Formosa Plastics

RE: EPA Request for Information  
Greenhouse Gas Permit Application  
Formosa Plastics Corporation, Texas  
2012 Expansion Project: Two Gas Turbines  
Point Comfort, Calhoun County, Texas

## Attachment

**FIGURE 1 – Major Inspection Work Scope<sup>1</sup>**

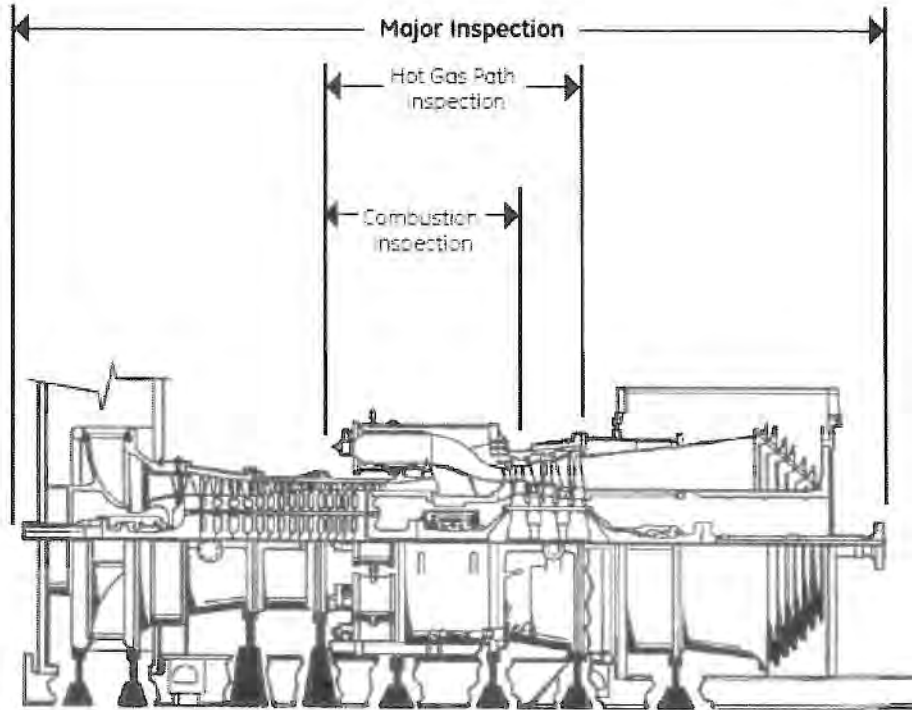
2. ***On page 28 of the permit application, it states that for burner maintenance "there are three basic maintenance levels: combustion inspections, hot gas path inspections, and major overhauls." Please provide supplemental details about each maintenance level such as what is involved, frequency of each level of maintenance, monitoring, and recordkeeping requirements.***

FPC TX Response: The following summarizes what is involved for burner and turbine maintenance in combustion inspections, hot gas path inspections and major overhauls:

- Combustion inspections require a disassembly shutdown. During this shutdown inspection is performed on fuel nozzles, liners, transition pieces, crossfire tubes and retainers, sparkplug assemblies, flame detectors and combustor sleeves. Inspections are performed to identify wear, erosion, corrosion, hot spots, cracks, plugging, clearance limits, and to replace consumable and normal wear and tear items such as seals, nuts, bolts, gaskets.

- Hot gas path inspections require that the top half of the turbine shell be removed and involve examination of parts exposed to high temperatures for the hot gases discharged from the combustion process. This includes detailed inspection of turbine nozzles, stator shrouds, turbine buckets, bushings, compressor blades, diffusers, and turbine shell and bushings for wear and tear, cracks, loose and missing parts, plugging, and corrosion.

- Major overhauls involve inspection of all of the major components of the gas turbine and includes elements of the combustion and hot gas path inspections, in addition to completely opening the entire turbine assembly for access to inspect the rotors, compressor blades, bearing assemblies, casing, compressor inlet and flow-path, actuators, gearing, nozzles, diaphragms, buckets for wear and tear, cracks, loose and missing parts, plugging, and corrosion.

Figure 1 illustrates the different scope of the three maintenance efforts.

These inspections are generally scheduled based on hours of operation and number of starts and stops on a cycle of the three type of inspections based on the number of run hours (approximately every 12,000 run hours) as follows:

<u>Run time Cycle</u>	<u>Inspection Cycle</u>
The first 12,000 hours - 500 day	Combustion
Another 12,000 hours	Hot Gas Path
Another 12,000 hours	Combustion
Another 12,000 hours	Major Overhaul

After the Major Overhaul the inspection cycle begins again starting with the Combustion Inspection. Additional maintenance may be required if high vibrations or exhaust temperatures are detected.

**FIGURE 2 – Typical DLN-1 Fuel Gas Split Schedule<sup>2</sup>**

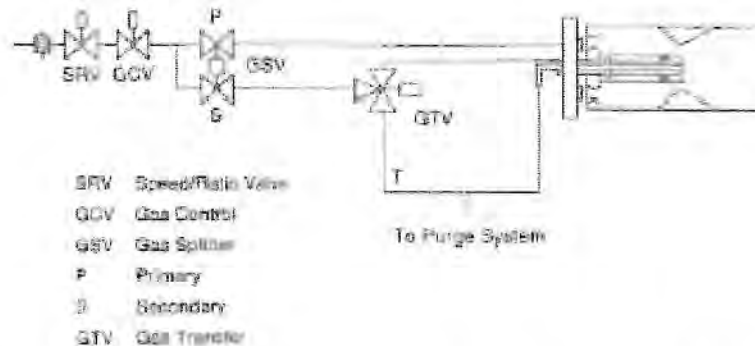
- ***How will proper air/fuel ratios assured?***

FPC TX Response: Proper air/fuel ratios are assured through the use of DLN burners which require controlled fuel distribution to primary and secondary stages of the DLN combustor which assures proper air to fuel ratios. See Figure 2 for a diagram of the

DLN gas fuel system. The fuel division is accomplished by a calibrated splitter valve to move to a set position based on the calculated combustion reference temperature as illustrated by Figure 3

**FIGURE 4 – Hydrocarbon and Moisture Superheat Requirements<sup>4</sup>**

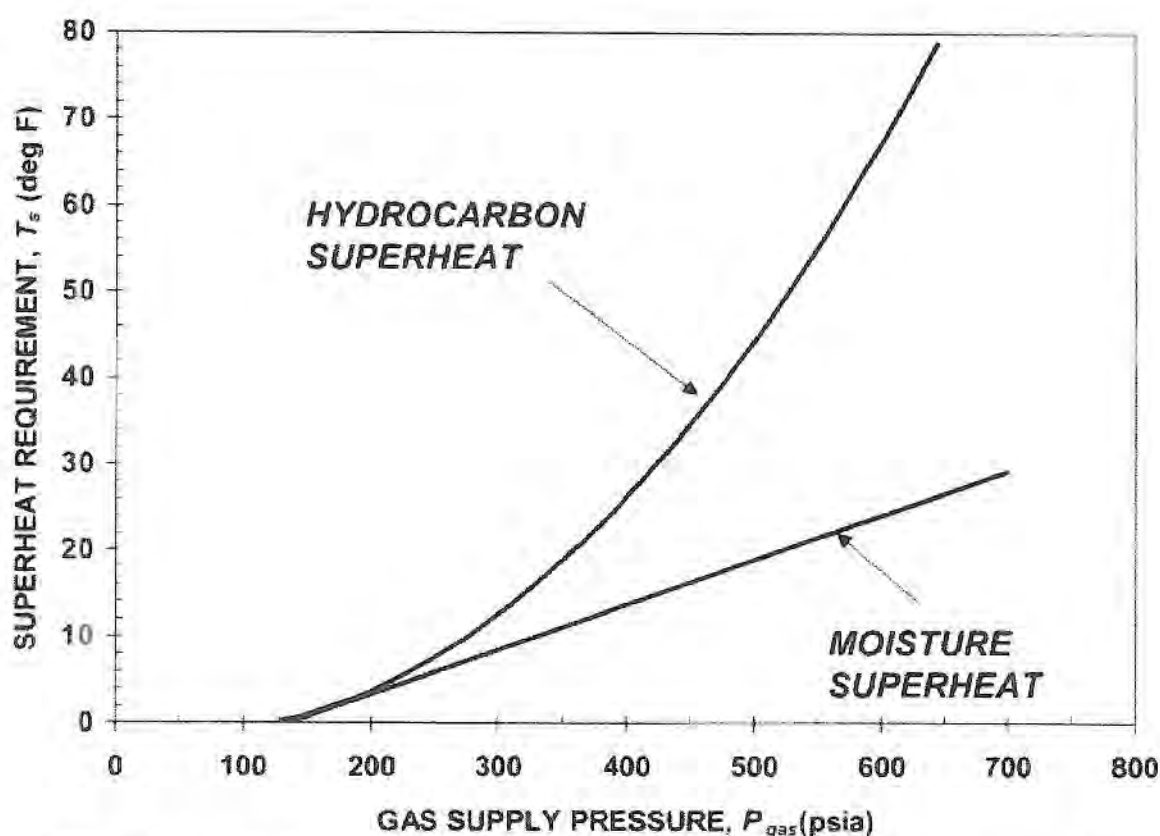
6. ***On page 31 of the permit application, it is stated that efficiency of the turbines is increased by superheating the fuel prior to combustion. The proposed BACT analysis on page 32 states that pre-heating will be utilized. Please provide any supplemental data that discusses improved percent increase of operating efficiency for the proposed combustion turbine compared to combustion turbines that do not utilize fuel pre-heating. How will heat transfer efficiency to the fuel be ascertained and assured for the fuel pre-heater?***

FPC TX Response: Fuel preheating is expected to result in increased operating efficiency because the amount of preheat is directly proportional to a reduction in required fuel fired (MMBtu) to raise the temperature of the fuel for combustion.

The increase in efficiency associated with fuel preheating is not expected to be exceptionally large (relative to unit's overall heat rate) and is identified as only one of many design elements which contribute to the overall CC unit energy efficiency. The actual amount of pre-heat is dynamic depending on the fuel gas delivery pressure and

composition. See Figure 4 which provides an illustration of a representative relationship between superheat requirements and gas supply pressure.

FPC TX will monitor the temperature of fuel supplied to the turbine to ensure the fuel meets the minimum temperature requirements prior to entering the turbine. The amount of preheat is directly correlated to the temperature of the fuel leaving the fuel gas heat exchanger.

# Typical Gas Turbine Heat Rate Ratio versus Partial Load

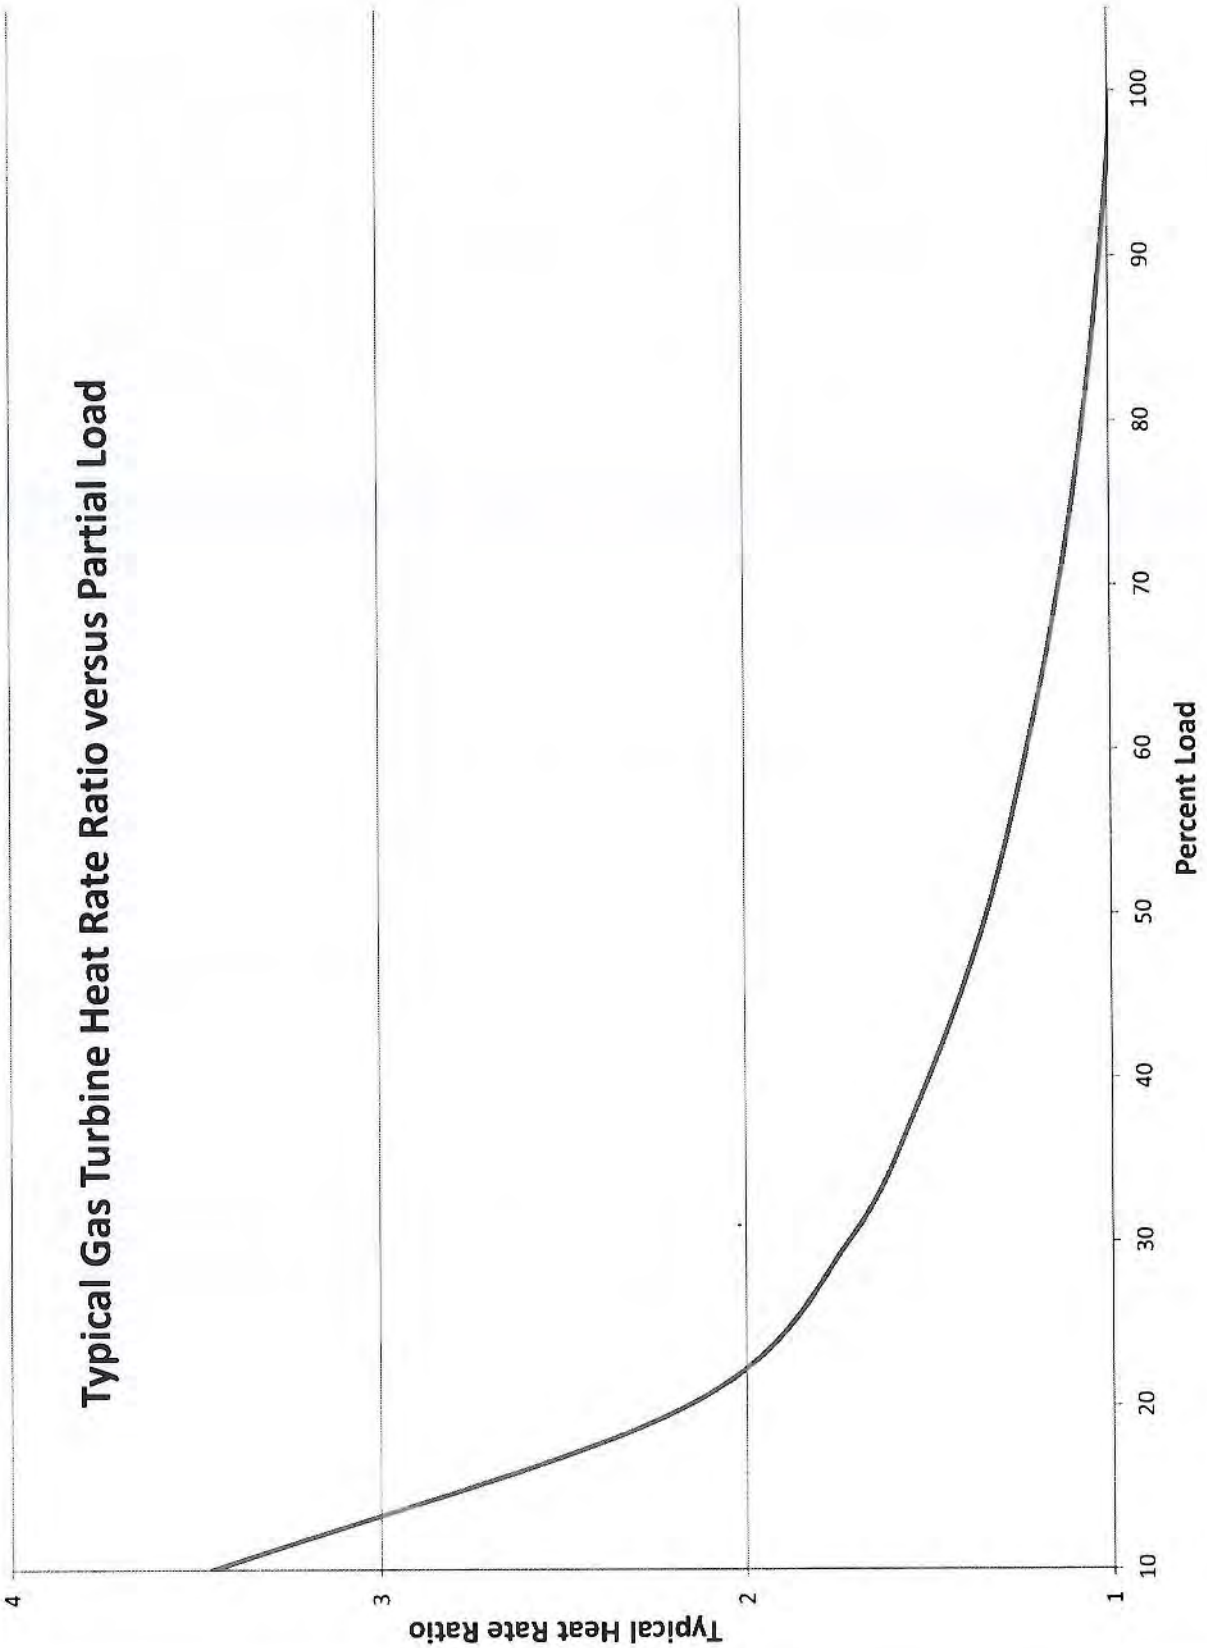
1. ***Please provide supplemental data that includes the efficiency and loading curve of the proposed turbine proposed for this project that supports describing the unit as "efficient turbine design". (this information may be represented graphically in load/efficiency curves). Also, please provide any benchmark data that compares this turbine to similarly designed combustion turbines that have been recently permitted by air permitting authorities nationwide.***

Even so, FPC TX has provided a copy of GE's Performance Curve (attached) for the 7EA turbine showing the relationship of heat rate ratio to turbine load.
